**COMPREHENSIVE WATER SUPPLY AND SEWERAGE SYSTEMS PLAN AMENDMENTS**

**County Executive's Transmittal Packet – July 2005: Map Amendment Summary Information Table**

**Piney Branch Watershed Cases:**

# Sewer Service Area Categories Map WSSCR 03A-TRV16 (Mike Tofigh)

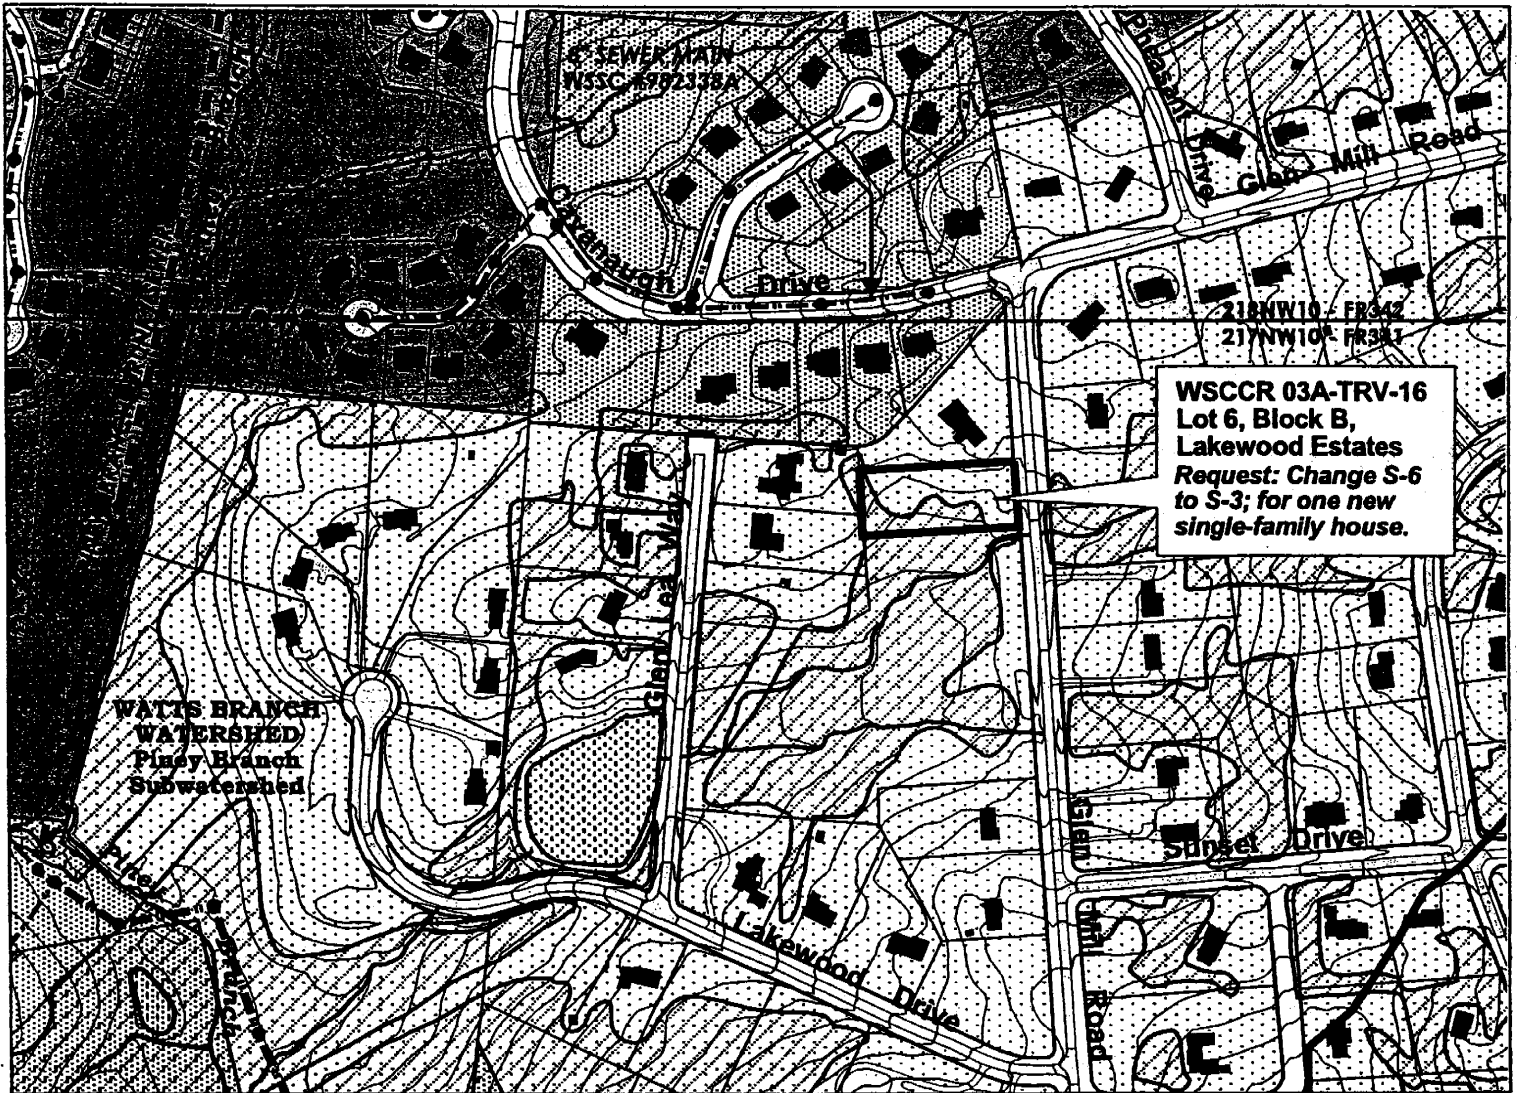
TRAVILAH PLANNING AREA – PINEY BRANCH WATERSHED CASES			
Map Amendment No. Applicant (Owner) Property Information Development	Applicant's Request: Service Area Categories		Reviewing Agency WSSC and DPS Comments (Main extensions are non-CIP sized unless specified.)
	Existing	Requested	
Applicant's Explanation			
<b>WSSCR 03A-TRV-16: Mike Tofigh</b>			
<ul style="list-style-type: none"> <li>• 13414 Glen Mill Rd. – Lot 6, Block B, Lakewood Estates</li> <li>• Map tile: 217NW10; FR341</li> <li>• West side of Glen Mill Rd., south of Cavanaugh Dr.</li> <li>• Potomac Subregion Master Plan (2002)</li> <li>• Watts Branch Watershed/Piney Branch Subwatershed (MDE Use I; Mont. Co. SPA)</li> <li>• RE-1 Zone; 0.8 ac.</li> <li>• Existing use: Vacant</li> <li>• Proposed use: 1 single-family house</li> </ul>	<p>W-1                      No Change S-6                      S-3</p> <p>Applicant's Explanation: "We are planning to build a single family house and there 200 feet away from the sewer line; and we are one lot away from a sewer connection."</p>	<p><u>M-NCPPC Staff:</u> pending – <i>DEP comment:</i> Sewer service is not consistent with the master plan.</p> <p><u>WSSC-Sewer:</u> Service will require a 600' main extension from an existing 8" main (#982338A) at Cavanaugh Dr. near Glen Mill Rd. The extension would be a combined gravity and low-pressure main requiring an on-site grinder pump. The extension would abut approx. 6 additional properties. WSSC would accept a pressure sewer system in this case due to concerns along the potential gravity alignment, which include steep slopes, a large pond, and natural gas transmission mains.</p> <p><u>DPS-Well &amp; Septic:</u> The property has failed percolation testing for a trench septic system due to shallow depth to groundwater. However, there has been no testing for a sand mound septic system.</p>

**Executive Staff Report:** The applicant has requested a sewer category change to support the construction of a single house on the existing lot. The provision of public sewer service is not consistent with either Water or Sewer Plan policies, or with master plan recommendations. The site is wholly located within the Piney Branch subwatershed and is therefore affected by the specific service policies and recommendations for sewer service there. At this time, the site does not satisfy any of the service requirements allowed under the restricted sewer service policy.

**County Executive Recommendation: Deny the sewer request, maintaining S-6.**

# Sewer Service Area Categories Map WSSCR 04A-TRV-03 (Lloyd Potter)

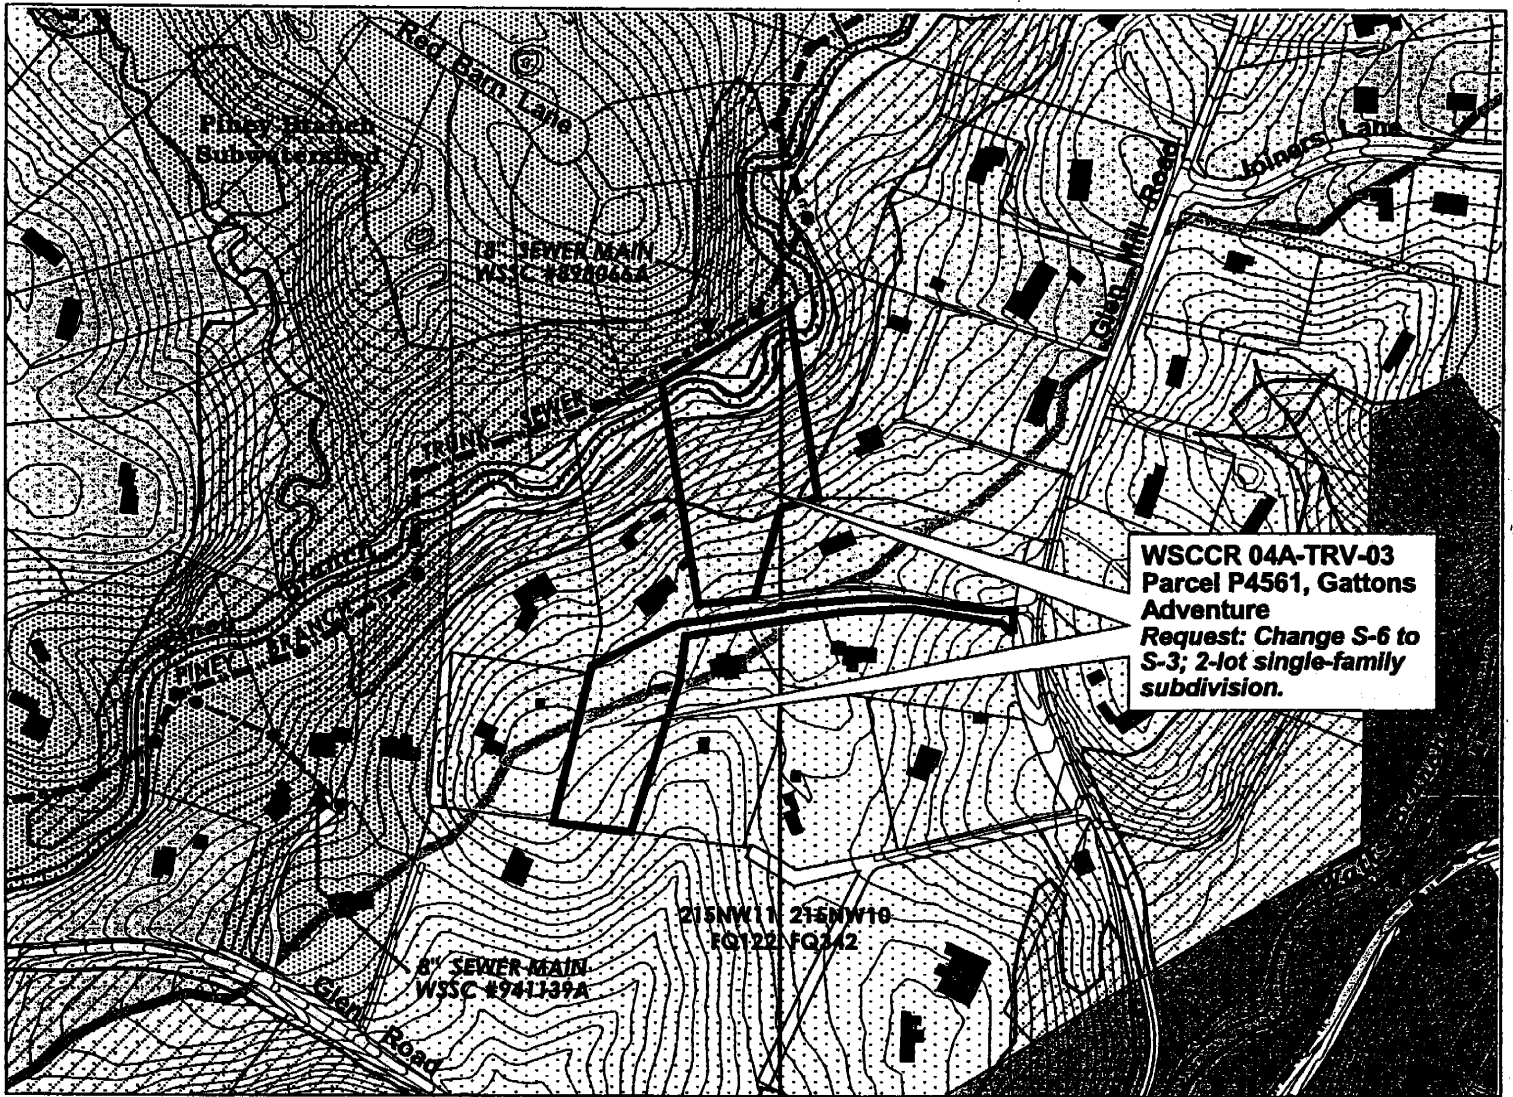
<b>WSSCR 04A-TRV-03: Lloyd Potter</b>		
<ul style="list-style-type: none"> <li>• (no premise address) – Parcel P461, Gattons Adventure</li> <li>• Map tile: 215NW10 &amp; 11; EQ122 &amp; FQ342</li> <li>• West side of Glen Mill Rd., south of Joiners Ln.</li> <li>• Potomac Subregion Master Plan (2002)</li> <li>• Watts Branch Watershed/Piney Branch Subwatershed (MDE Use I; Mont. Co. SPA)</li> <li>• RE-2 Zone; 4.85 ac.</li> <li>• Existing use: Vacant</li> <li>• Proposed use: subdivide into 2 single-family building lots; plan no. 1-05048 – Glen Estates (note: This plan proposes septic use for both lots).</li> </ul>	<p>W-1                      No Change S-6                      S-3</p> <p>Applicant's Explanation: (None provided, except under "proposed use".)</p>	<p><u>M-NCPPC Staff:</u> pending – <i>DEP comment:</i> Although sewer service may be consistent with the Piney Branch Sewer policy, service will require crossing the Piney Branch, which should be avoided.</p> <p><u>WSSC-Sewer:</u> Service to the northern piece of the property can be provided from the existing 18" Piney Branch Trunk Sewer (#89CT8066A). Service for the southern piece of the property will require a 400' main extension from an existing 8" main (#941139A) located west of the property. The extension would abut approx. 3 additional properties and would require rights-of-way. Construction may require removing trees.</p> <p><u>DPS-Well &amp; Septic:</u> This office has approved two septic areas for this property. They can build two houses.</p>

**Executive Staff Report:** The applicant has requested a sewer category change to support the construction of two single-family houses, one on each piece of the existing parcel. The northern piece of the parcel, which abuts the Piney Branch Trunk Sewer easement, qualifies for sewer service under the provisions of the restricted sewer access policy, as recommended in the master plan and adopted in the Water and Sewer Plan. Sewer service will require that the service connection/hookup cross Piney Branch. Although this situation is not inconsistent with the restricted sewer service policy, it raises questions about the environmental impacts of providing sewer service: a stream crossing, stream buffer impacts, and loss of trees. In addition, DPS has advised that this site is approved for a septic system. Given these circumstances, using a septic system to support the construction of a house on this site is the preferable alternative.

The southern piece of the property is located largely outside the Piney Branch Watershed. The provision of public sewer service to this RE-2-zoned area is inconsistent with Water and Sewer Plan policies and with master plan recommendations. The applicant should proceed with the use of the approved septic system on this property.

**County Executive Recommendation:** Deny the sewer request; maintaining S-6.
